Planning Application Ref: A/192/21/T

Location: Field House, The Thatchway, Angmering, BN16 4HJ

Description of works: Crown lift 1no. Turkey oak (T1) to 7m

Figure 2 Positions of final cuts

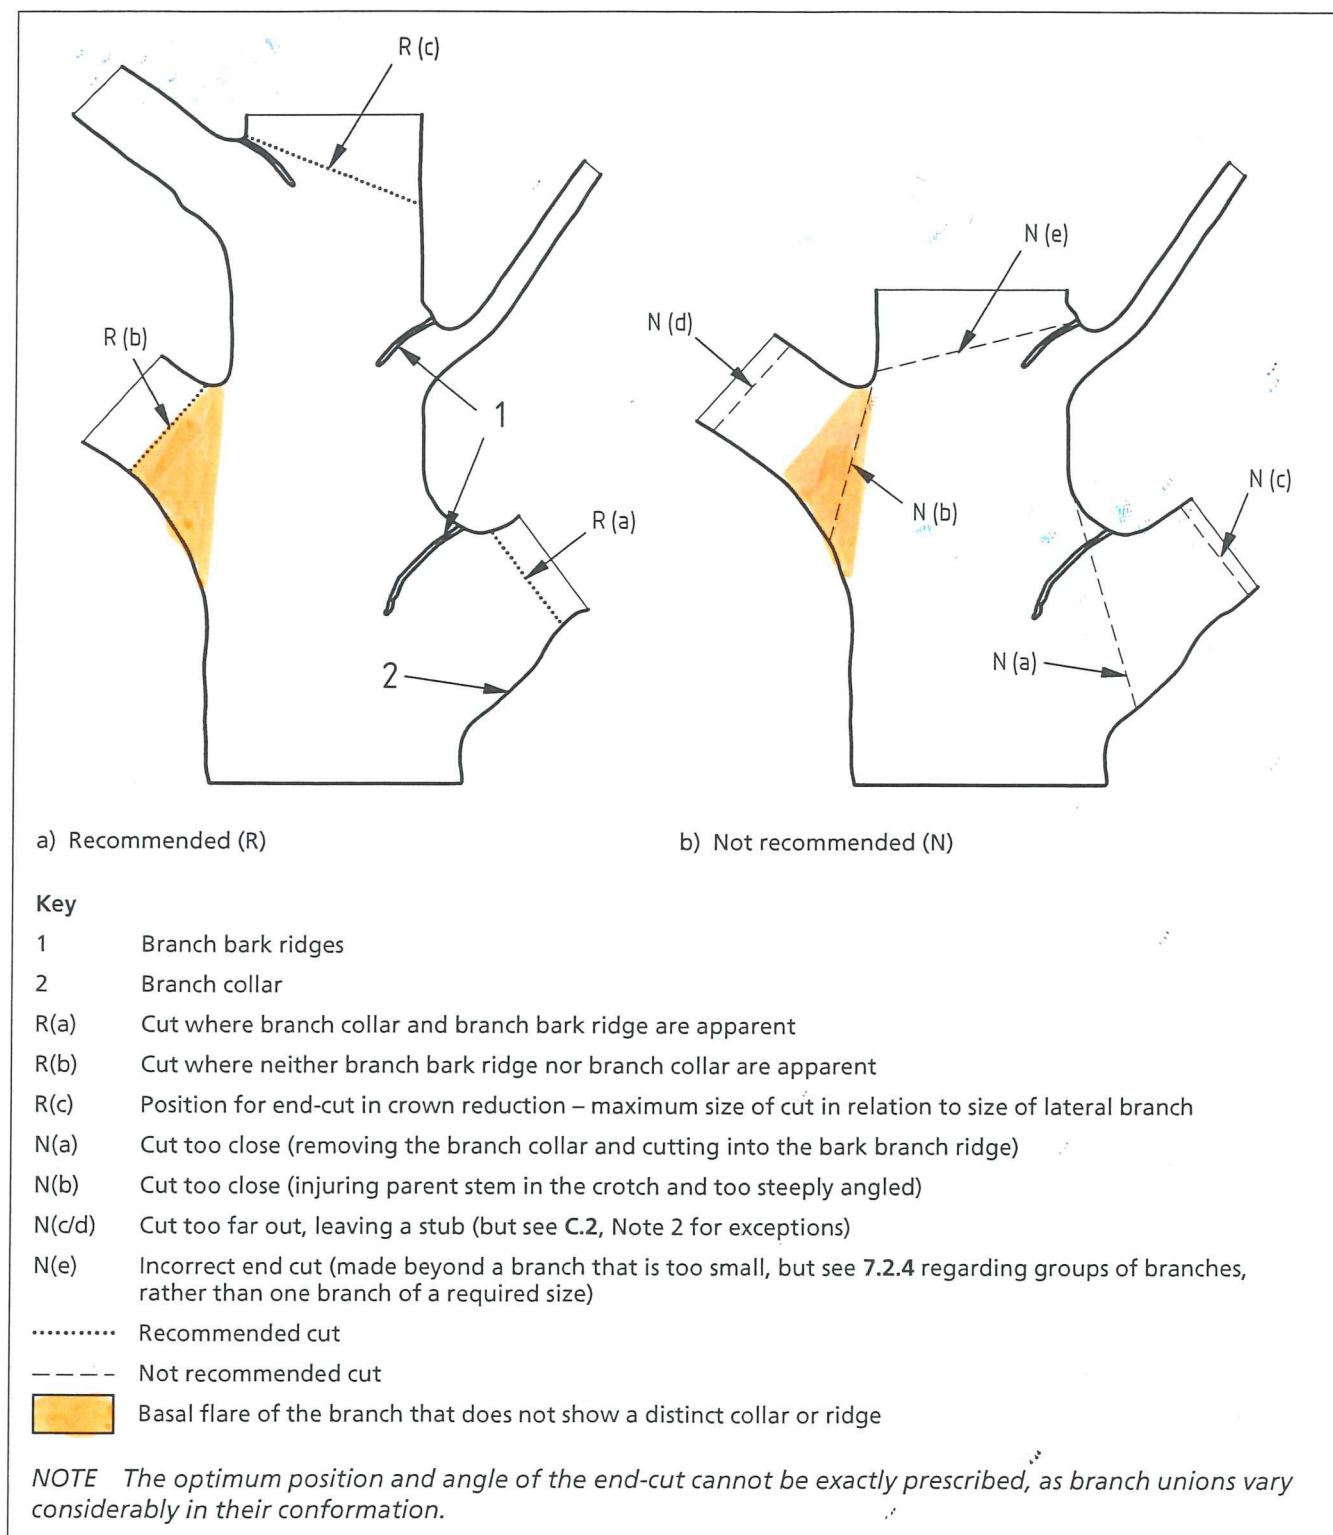
Part a) Where whole branches are to be removed and final cuts made close to the trunk or branch union they are to be made as shown in Figure 2 of BS3998:2010
